HIGH-LEVEL WASTE **TANK CLOSURE**

Final Environmental Impact Statement

DEPARTMENT OF ENERGY
SAVANNAH RIVER
OPERATIONS OFFICE
AIKEN, SOUTH CAROLINA
DOE/EIS-0303

May 2002

Figure 3.1-3. Savannah River Site, showing seismic fault lines and locations of onsite earthquakes and their years of occurrence.

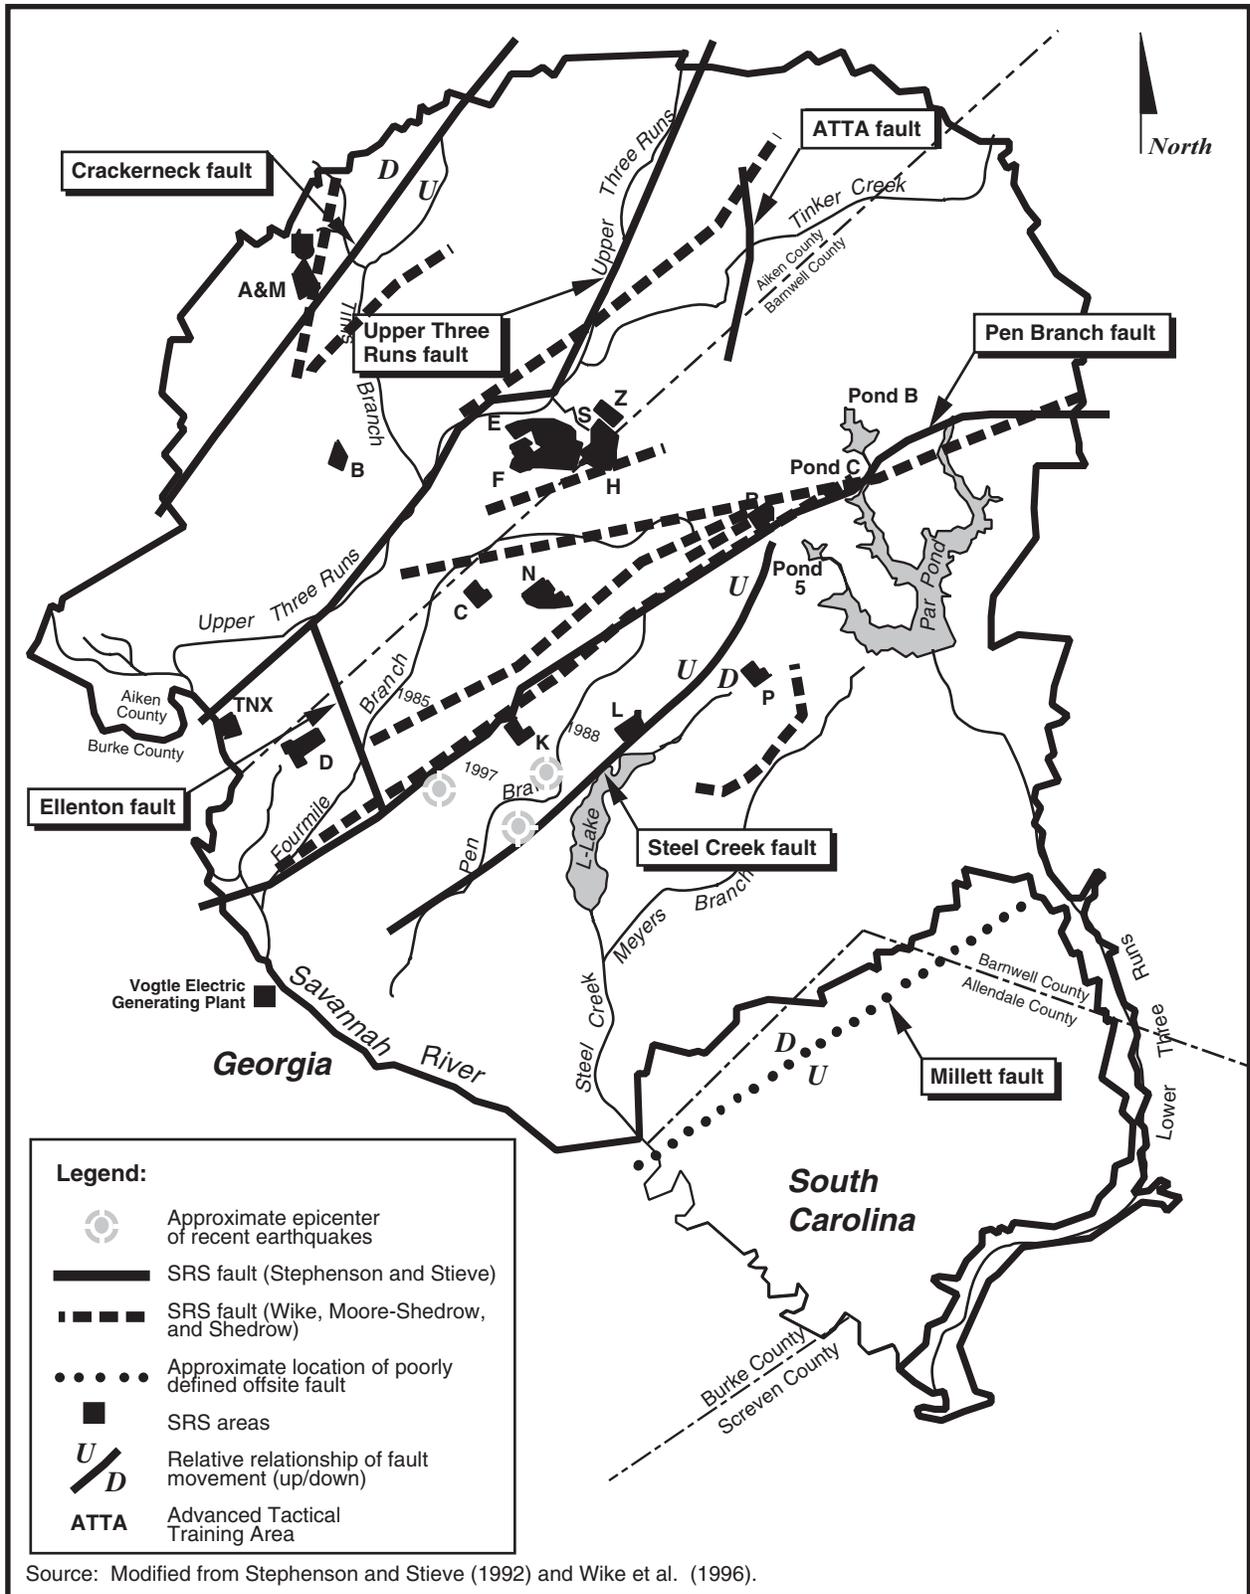
Section 3.1.3 (Seismicity) and Figure 3.1.1 (map of seismic fault lines) of EIS-0303D indicate the presence of a previously unknown fault (H-Fault ... for lack of another name) that passes through the southeastern corner of H-Area (Wike et al. 1996, WSRC-TR-96-0279 Rev. 1, p4-14). Previous hydro-geological studies of Sr-90 transport (Carlton et al., WSRC-RP-92-984) in this same area of SRS (Four-Mile Creek side of the water table divide) report that "much of the groundwater flow in this area of the plant appears to occur in narrow, high permeability channels in the sediments." It was suggested that the majority of the flow of underground contaminants entering the water table in this portion of H-Area follow these channels to outcrop into Four-Mile Creek. A similar study of Cs-137 transport (Carlton et al., WSRC-RP-92-250, p4-11) suggests "facilitated transport is taking place in this locality."

Figure 3.2-5. Maximum reported groundwater contamination in excess of regulatory/DOE limits at Savannah River Site.

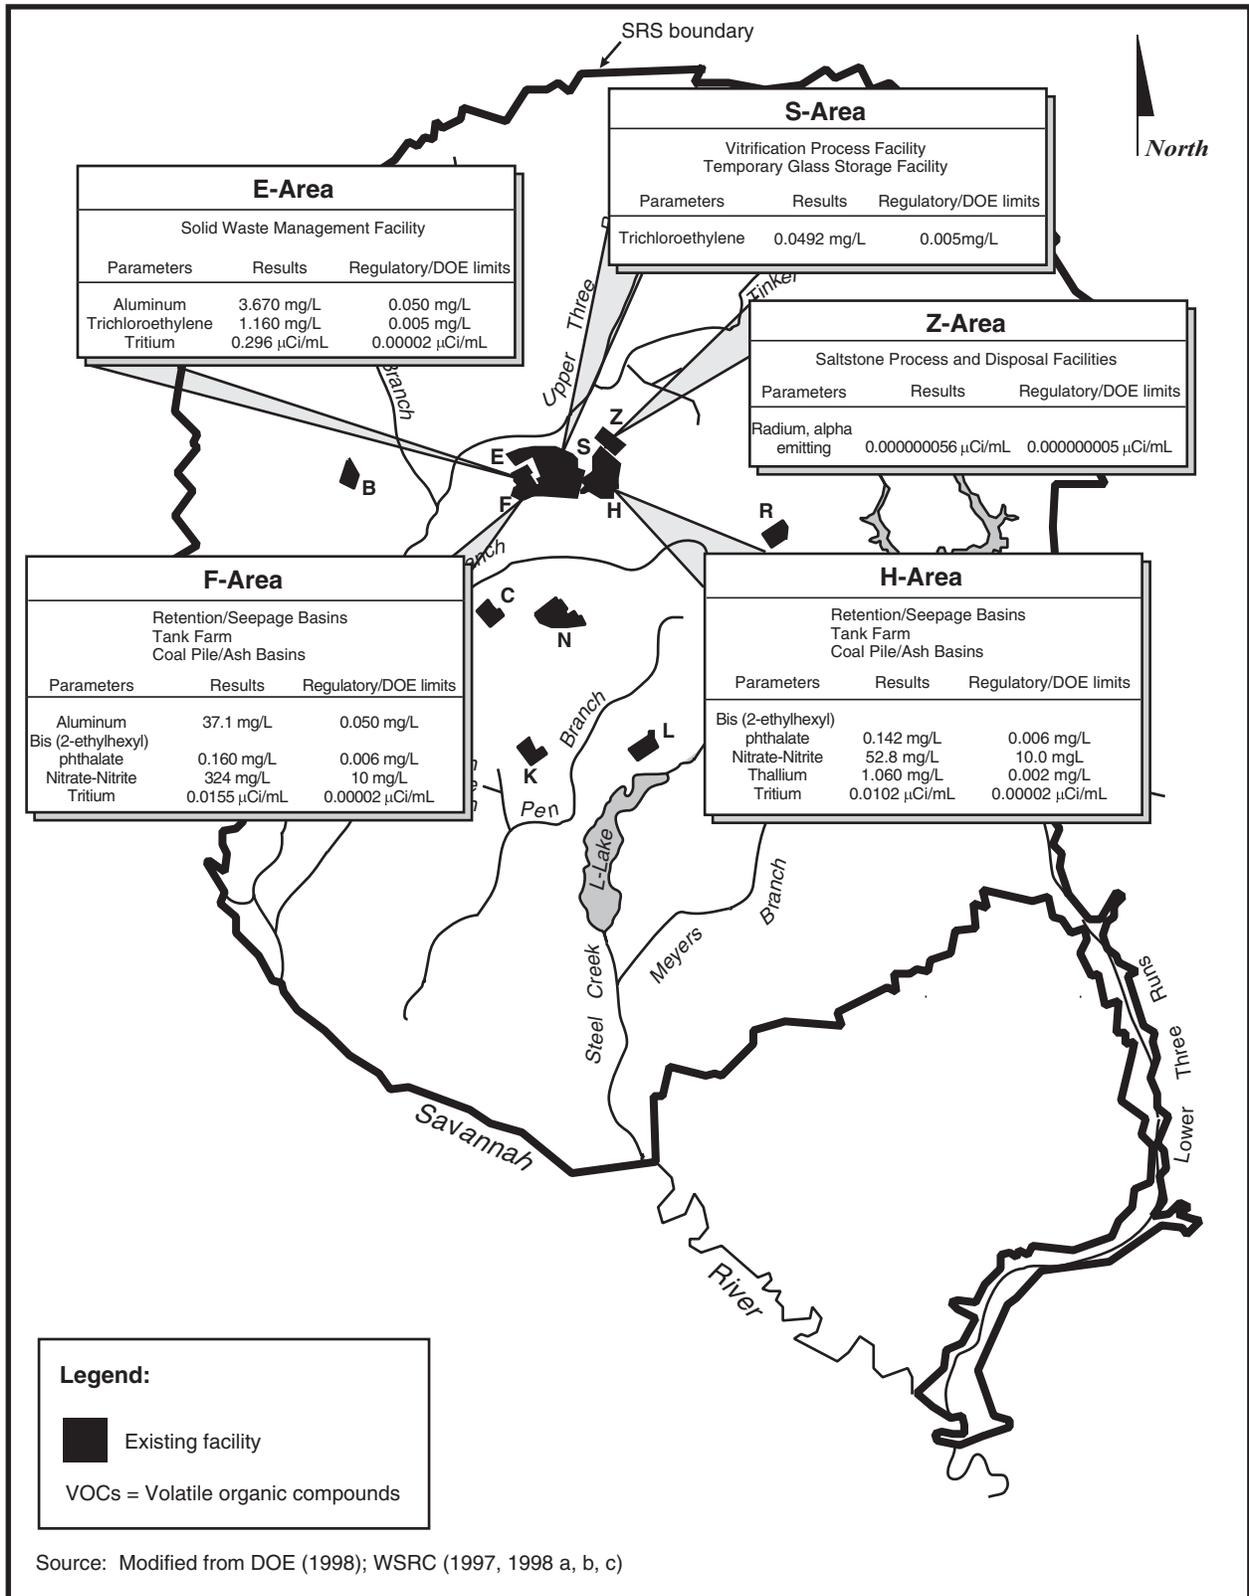
Tables 3.2-3, 3.2-4, and 3.2-5 report the maximum groundwater contaminant concentrations for parameters in excess of the regulatory limit for E-Area, F-Area, and H-Area, respectively. Likewise, Figure 3.2-5 provides a map of these areas with some of the same results listed. However, there may be a typo or else some confusion over units for tritium. The tables provide tritium concentrations in uCi/ml (micro), whereas the map reports tritium concentrations in mCi/ml (milli). For example, Table 3.2-3 indicates that the maximum tritium concentration in E-Area was 2.96×10^{-1} uCi/ml, whereas Figure 3.2-5 indicates that the maximum concentration was 0.296 mCi/ml, which would actually be 2.96×10^{-2} uCi/ml or 1000 times higher than reported in the table. Presumably the intent was to report in uCi/ml.

Response to comment L-13-4: The units shown on Figure 3.2-5 for tritium were incorrect and have been revised (all constituents, in addition to tritium, have been checked and revised as needed).

Figure 4.2.2-1. Predicted drinking water dose over time at the H-Area seepline north of the groundwater divide in the Barnwell-McBean and Water Table Aquifers.

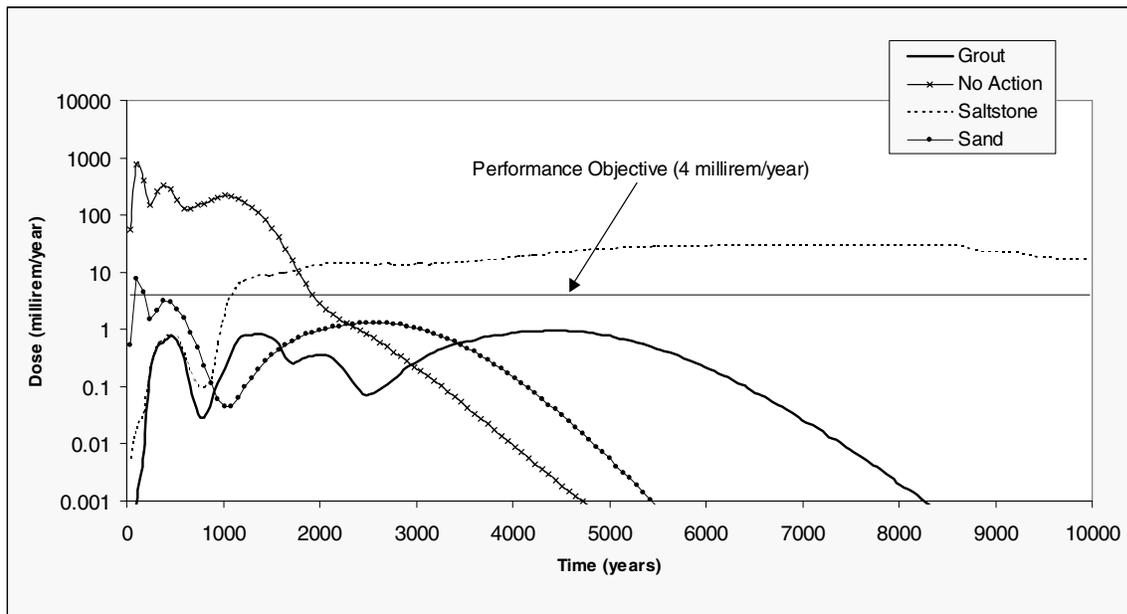
| 8. Figure S-7: To assist the reader in being able to quickly see when the closure criteria is estimated to become exceeded and by how much, please draw a horizontal line in the figure at 4 mrem to represent the closure criteria. | L-2-13 |

6. Table 4.2.2-6 (page 4-37) doesn't seem to include iron from the steel of the tanks. What are the impacts of this iron? | L-7-49
7. Text associated with Figure 4.2.2-1, should describe when the plutonium is expected to arrive at the seep line and what impact it may have on dose rate. I expect it is beyond the 10,000 year analysis period but still should be given in the EIS. | L-7-50

Response to comment L-2-13: Both figures S-7 and 4.2.2-1 have been modified accordingly.

EC | **Figure A-5.** Typical layers of the Fill with Grout Option.

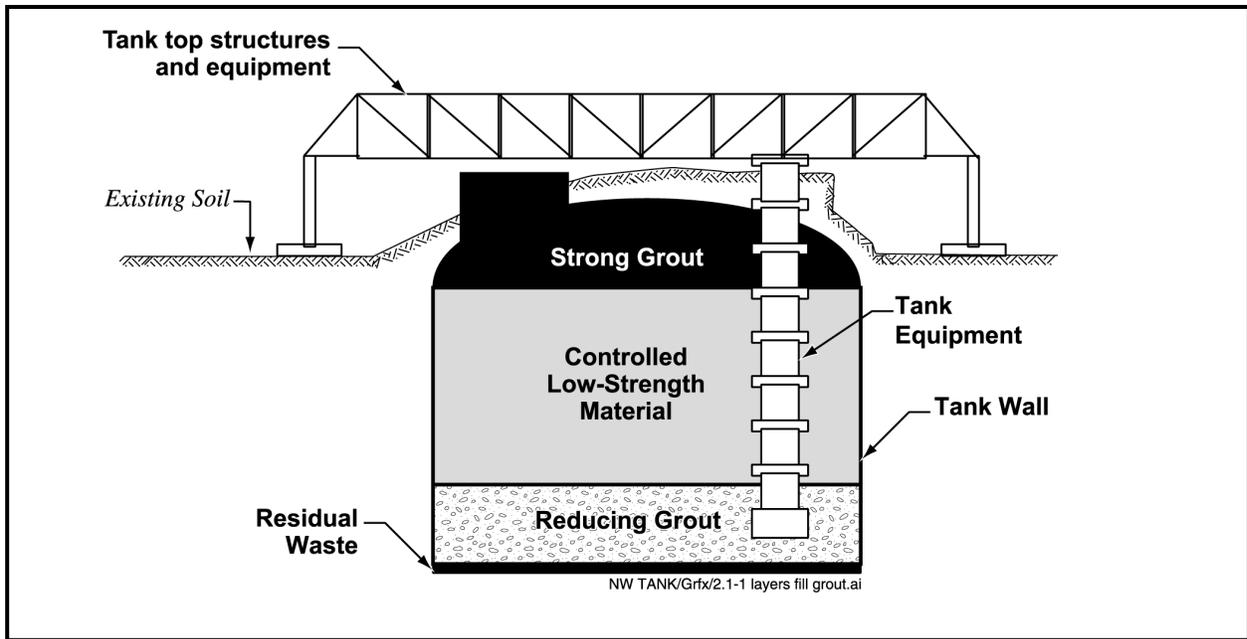
| 2. Figure A-5: The illustration of the tanks that have already been closed (Numbers 20 and 17) is not clear from the figure. Maybe drawing a line through them or separating them from the pack would be clearer. | L-2-16 |

Response to comment L-2-16: Figure E-4 (which was Figure A-5 in the Draft EIS) has been revised to show an “X” through Tanks 17 and 20.

Figure A-6. Area closure example.

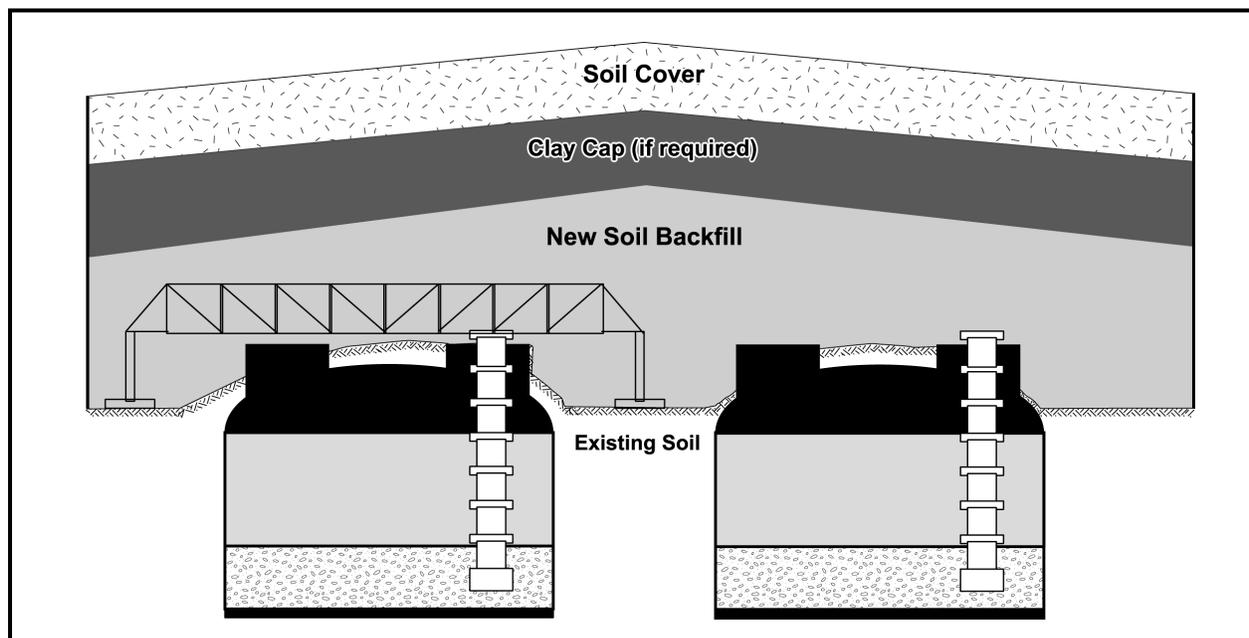
7. Page A-21: While helpful, Figure A-7 seems unclear. Describe the different elements inside of the tanks (viz., currently, the tanks are divided into four unnamed sections; contrast this figure with the clearer Figure 2.1-1). | L-2-21

Response to comment L-2-21: Figure A-6 is provided to present an environmental restoration concept with backfill material and a RCRA/CERCLA type cap shown over the closed tanks. See Figure A-5, Section A.4.4 (which is the same base figure as Figure 2.1-1) for more detail.

Figure C-2. Potential exposure pathways for human receptors.

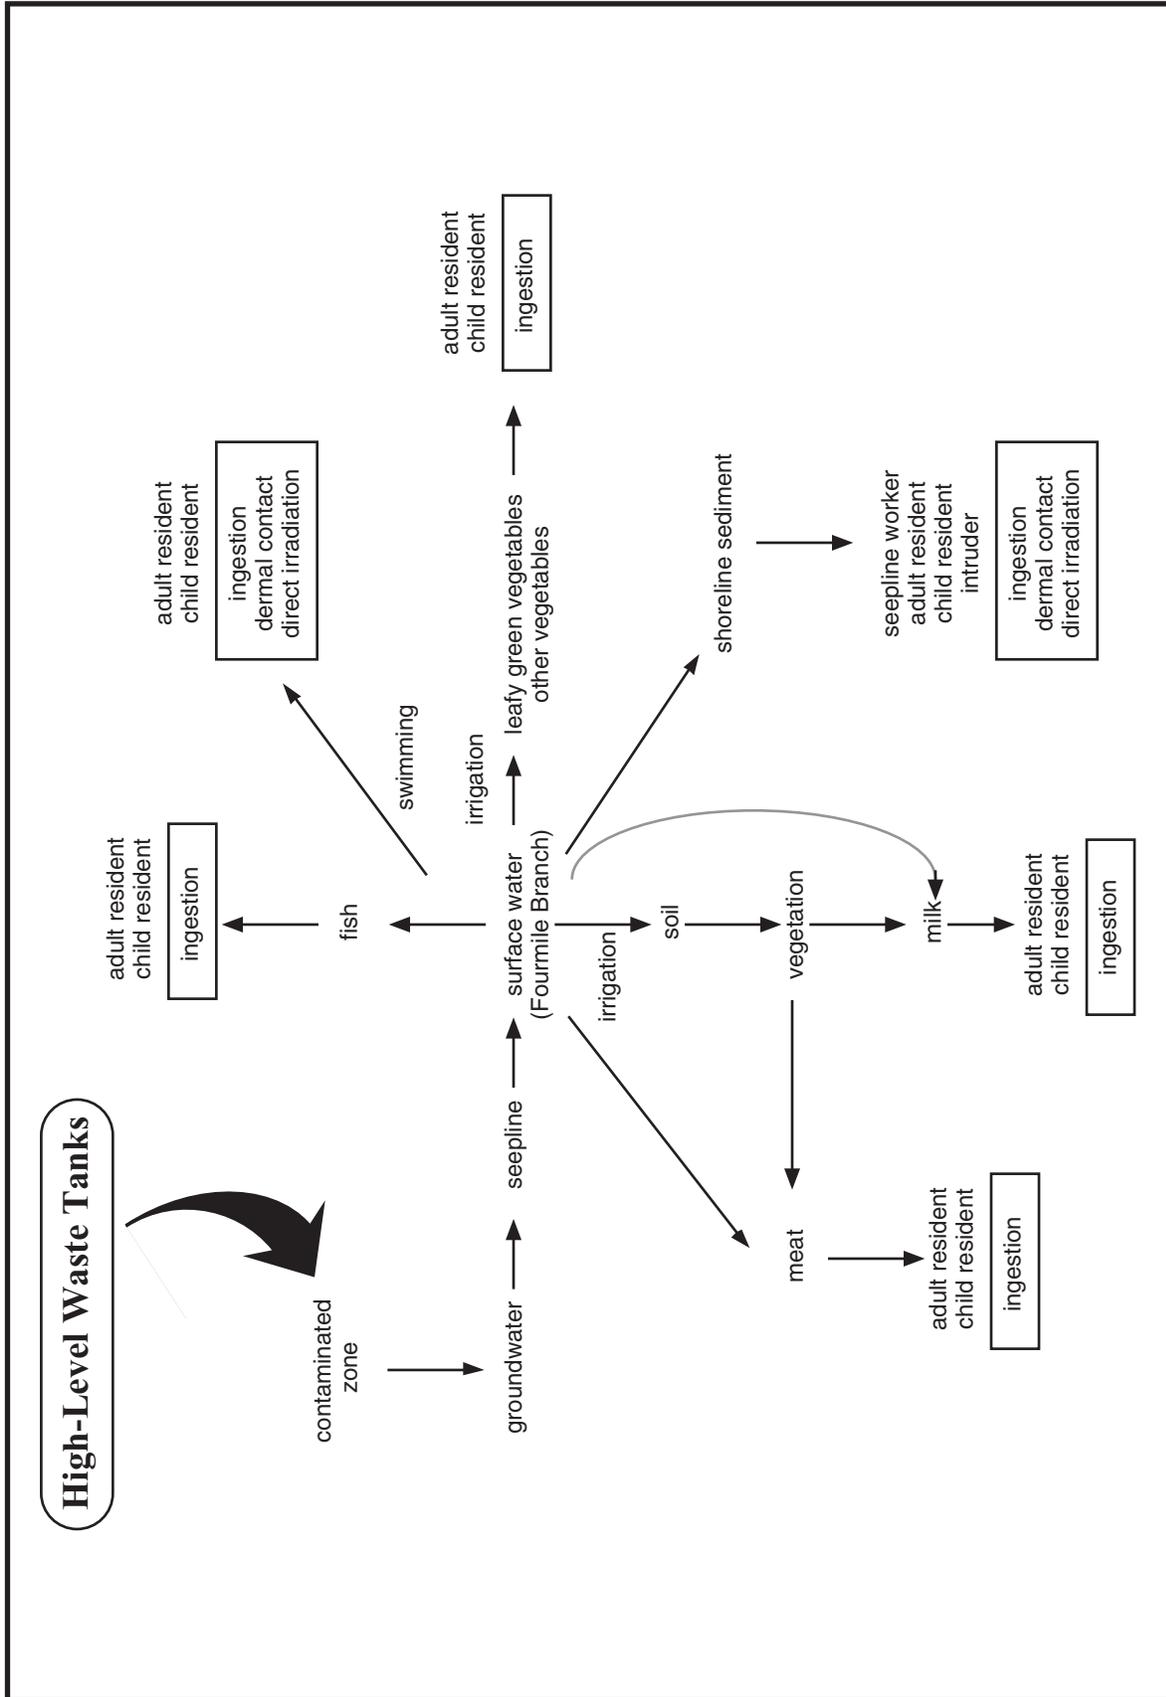
23. Page C-10, Figure C-2, Terrestrial Wildlife Column: When eating, the animals selected could also ingest sediment as well as soils. As a result, clarification is needed on page C-11, Column 2, last section regarding exposure routes. | L-4-26
